MEMORANDUM

Date: January 06, 2015
To: David Bonk, Kumar Neppalli, PE
Town of Chapel Hill, North Carolina
From: Bill Schultheiss, PE
Re: South Columbia Street and Otey's Road Safety Review and Concept Development

Toole Design Group (TDG) was retained by the Town of Chapel Hill to review a concept design developed by Kimley-Horn and Associates, Inc. (KHI) at the northern intersection of South Columbia Street at Fordham Boulevard (attached as exhibit 2), to develop concept design alternatives for South Columbia Street from Purefoy Road to Culver Road, and to develop a crossing improvement concept for Otey's Road at Fordham Boulevard.

SHEET NAME:
S. COLUMBIA AT
FORDHAM BLVD
WESTBOUND RAMP
DRAWING NUMBER
SK-4
SHEET NUMBER
4 OF **13**

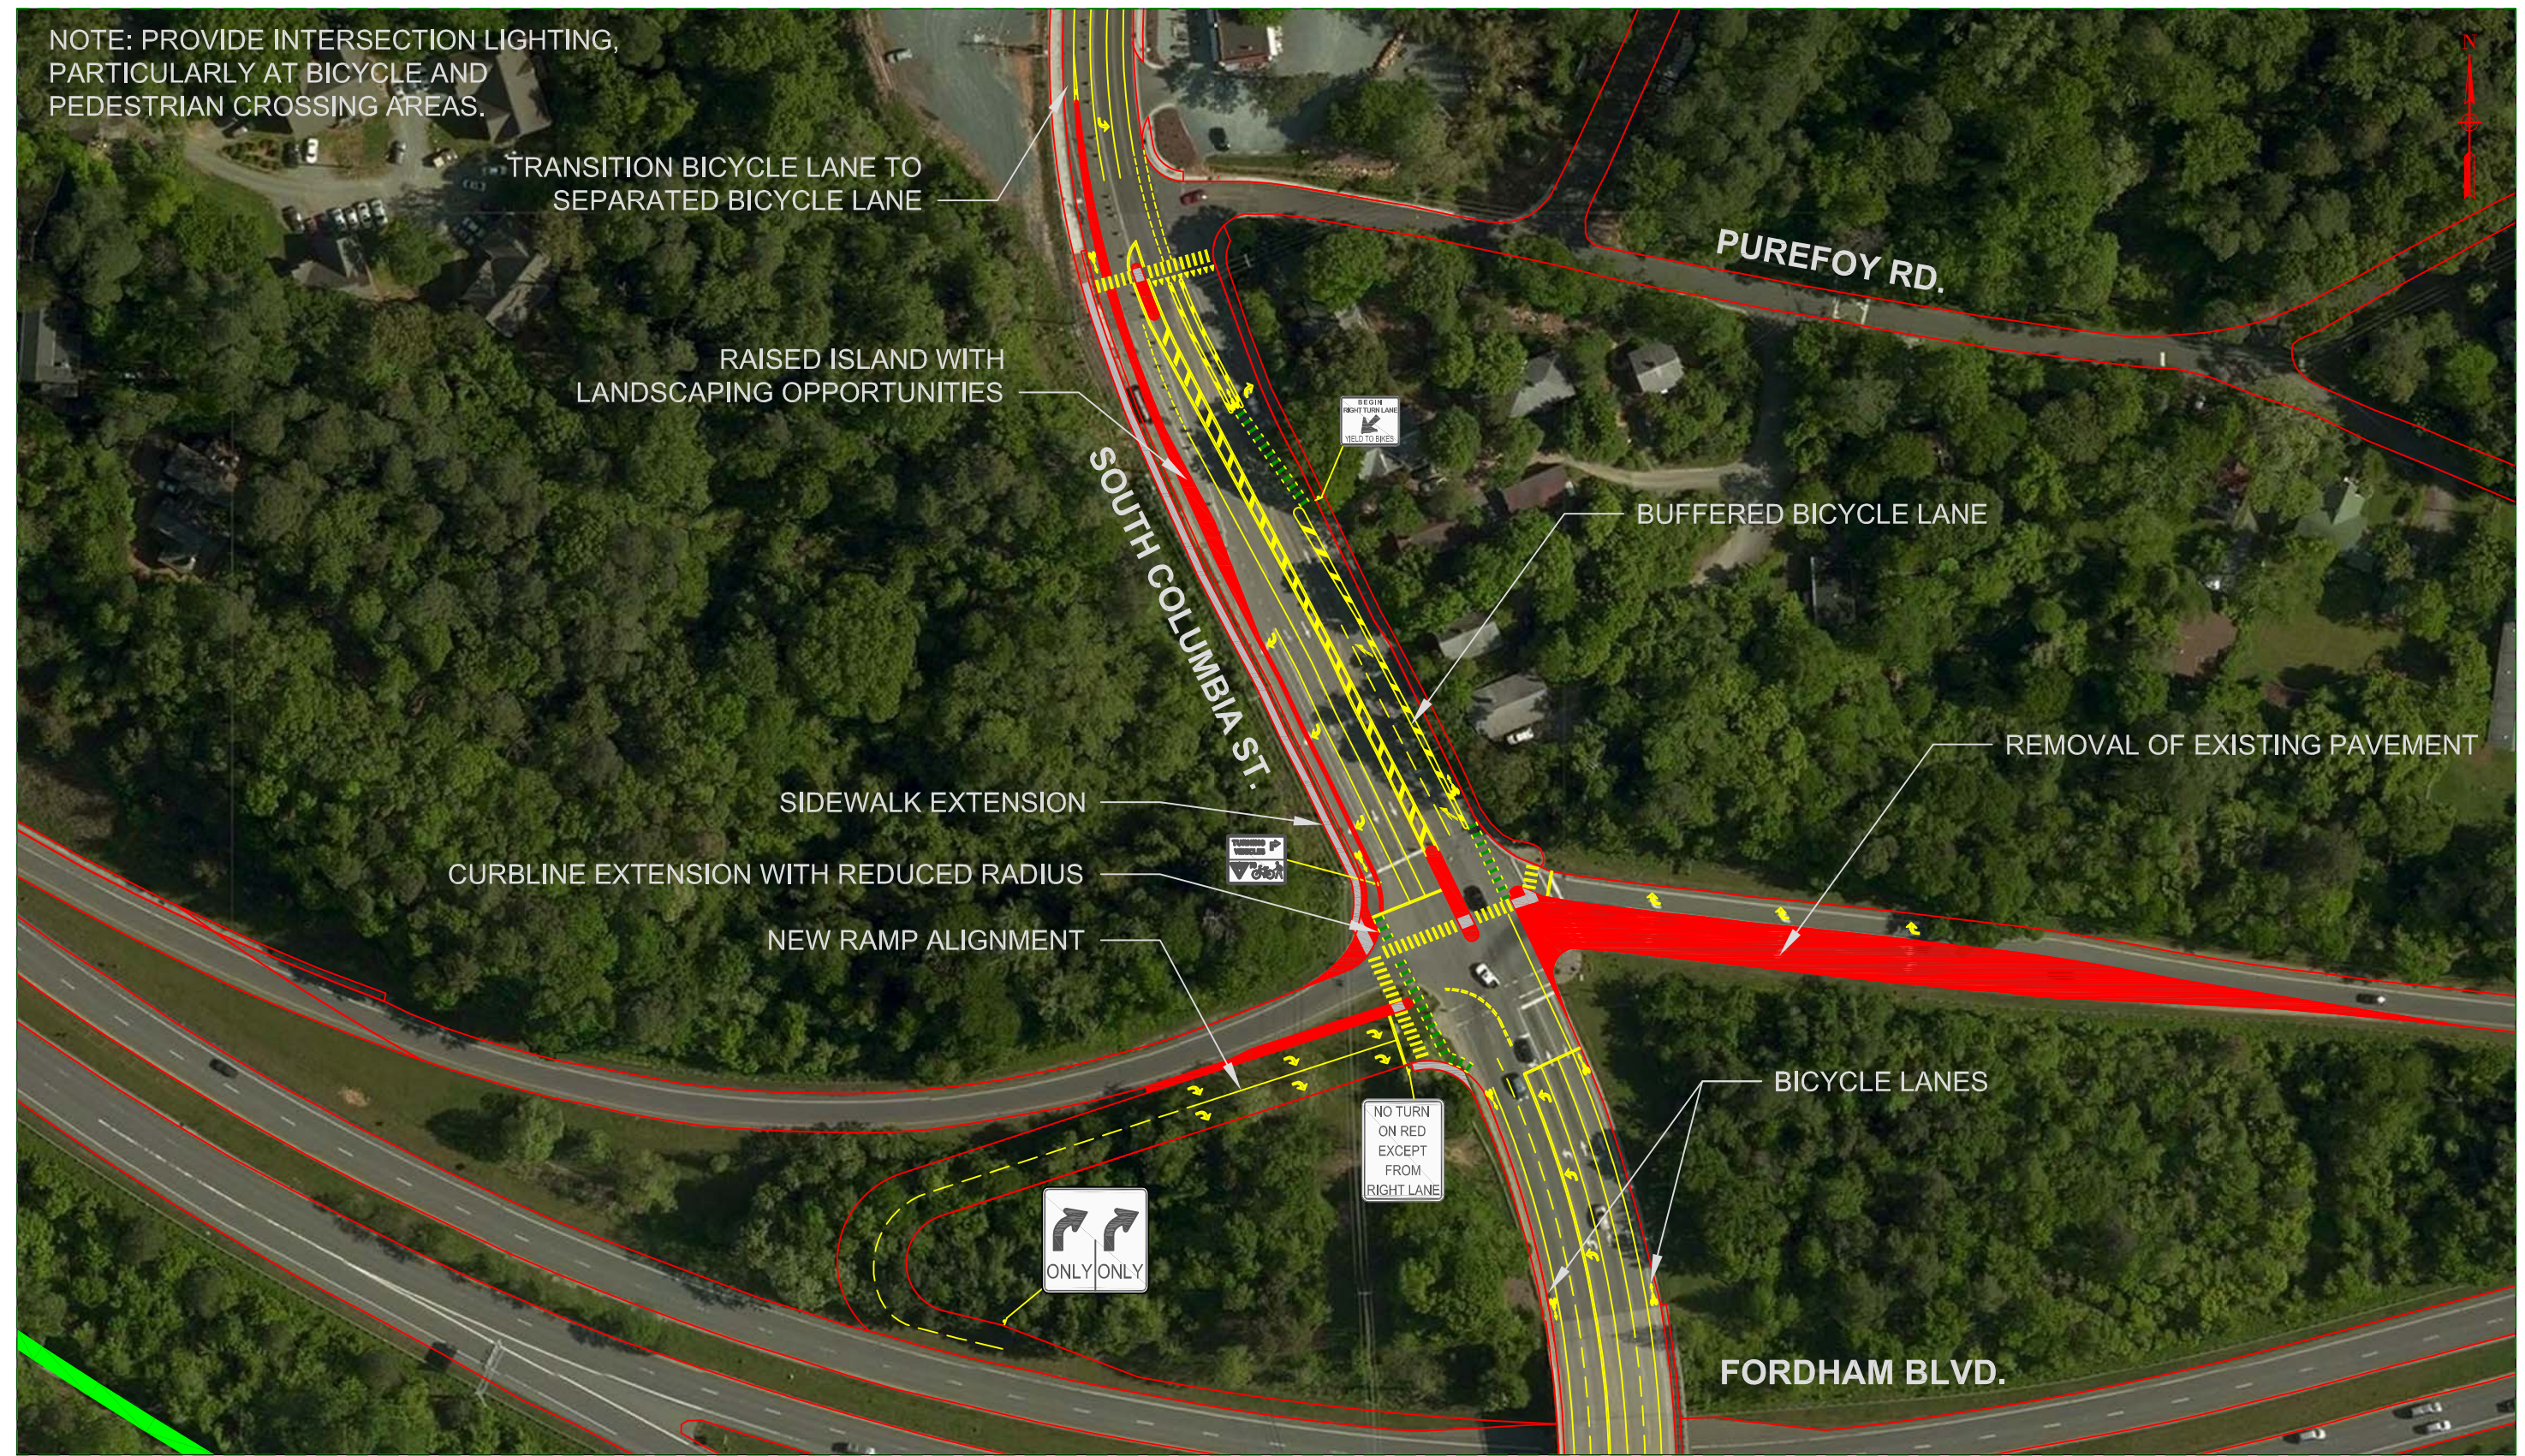
Alternative 2 depicts includes many of the recommendations from Alternative 1, but provides a higher level of change by removing all slip ramp designs. Additionally for southbound bicyclists, the bicycle lane is replaced by a

curb protected bicycle lane. The curb protected bicycle lane replaces the extended merging area with a single conflict point the combined bicycle and pedestrian crossing. The design of the corner promotes yielding by reducing bicyclists approach speeds and motorists turning speeds.

SHEET NAME:
 Oteys Road
 Proposed Condition
 DRAWING NUMBER
SK-11
 SHEET NUMBER
11 OF **13**

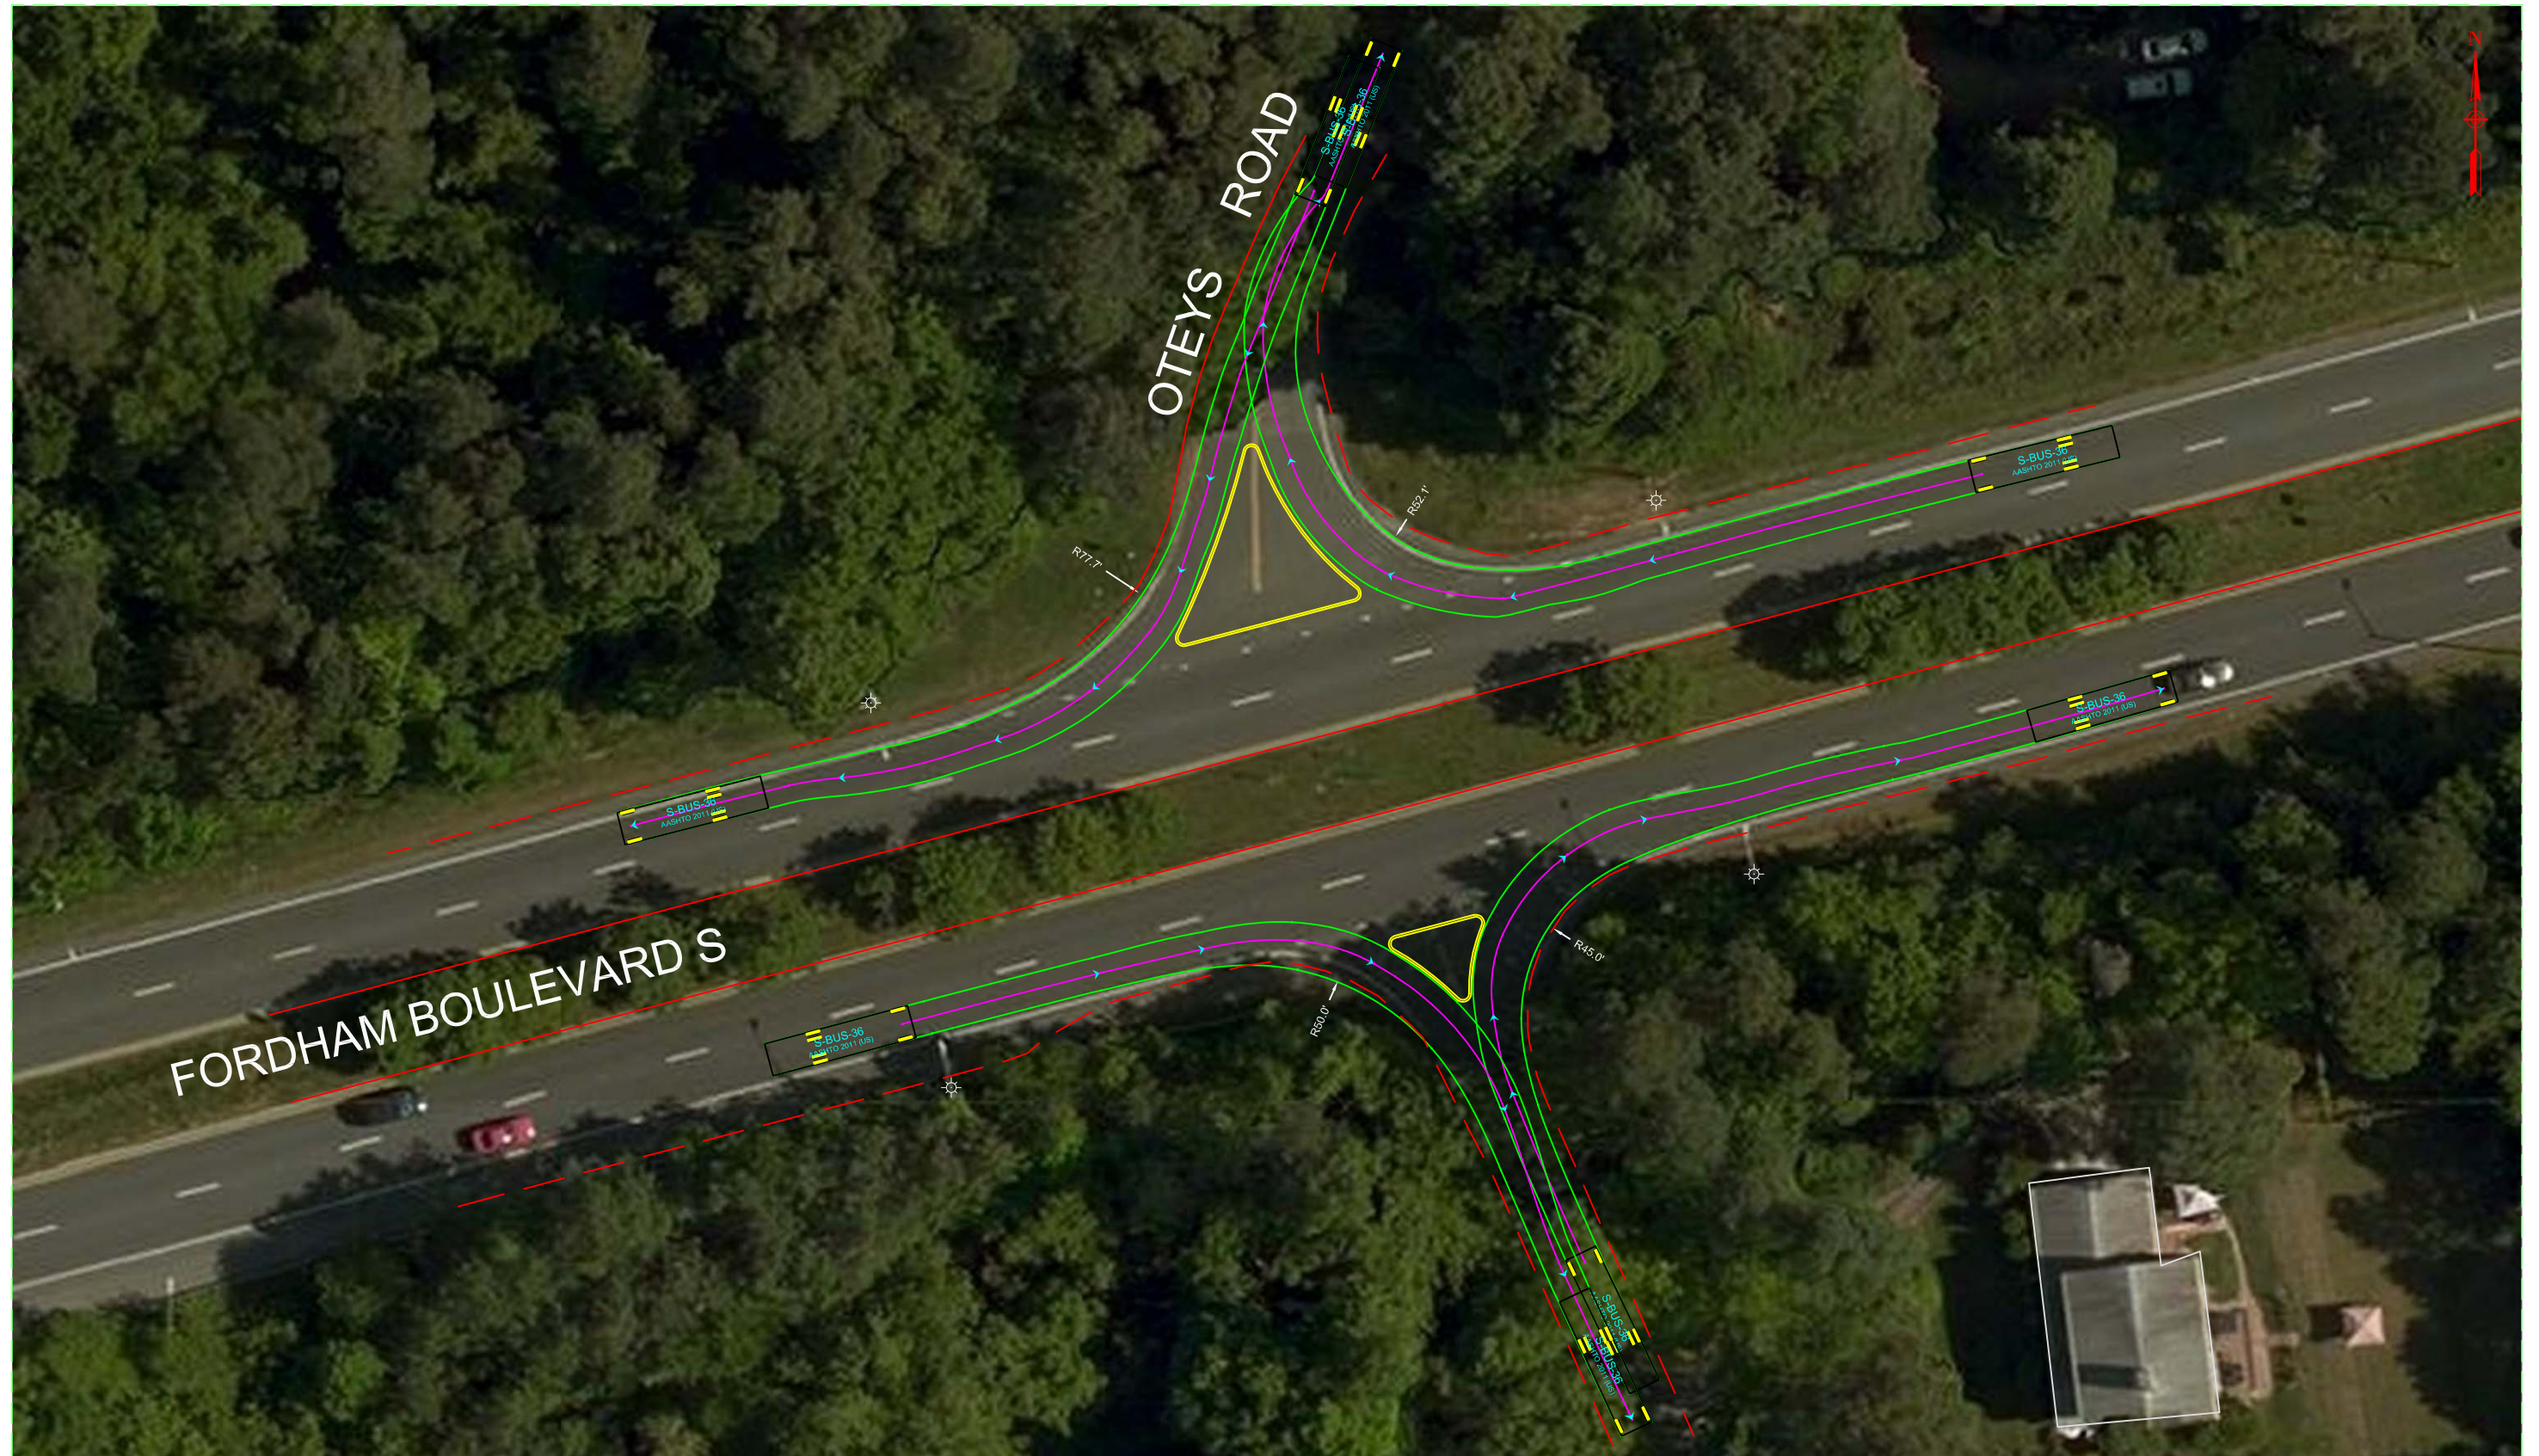
The Town and UNC bicycle plans recommended development of a pedestrian and bicyclist crossing of Fordham Boulevard. Provision of a safe crossing at this location would create an additional crossing between South Columbia Street and Manning Drive for non-motorized travel. Fordham Boulevard acts as a significant barrier to non-motorized travel as Manning Drive and South Columbia streets are separated by more than one mile. To safely cross Fordham Boulevard it will be necessary to modify the median to provide refuge, channelize traffic turning onto and off from Fordham Boulevard, and to install a traffic signal to stop traffic on Fordham Boulevard. The traffic signal can potentially be Pedestrian Hybrid Beacon or a full traffic signal. Given the lower volume of pedestrian and bicycle traffic likely this location it is recommended a relatively hot response be provided to reduce the likelihood of users crossing against the light as gaps in traffic appear. The maximum wait time is suggested at 30 seconds. If this is not achievable, it is advisable the signal at least be coordinated with the signal at Manning Drive.

- Crossing island improvements for bicyclist and pedestrians within the median
- Sidewalk improvements
- Proposed location for channelizing islands on Otey's Road
- Proposed HAWK signal on Fordham Boulevard
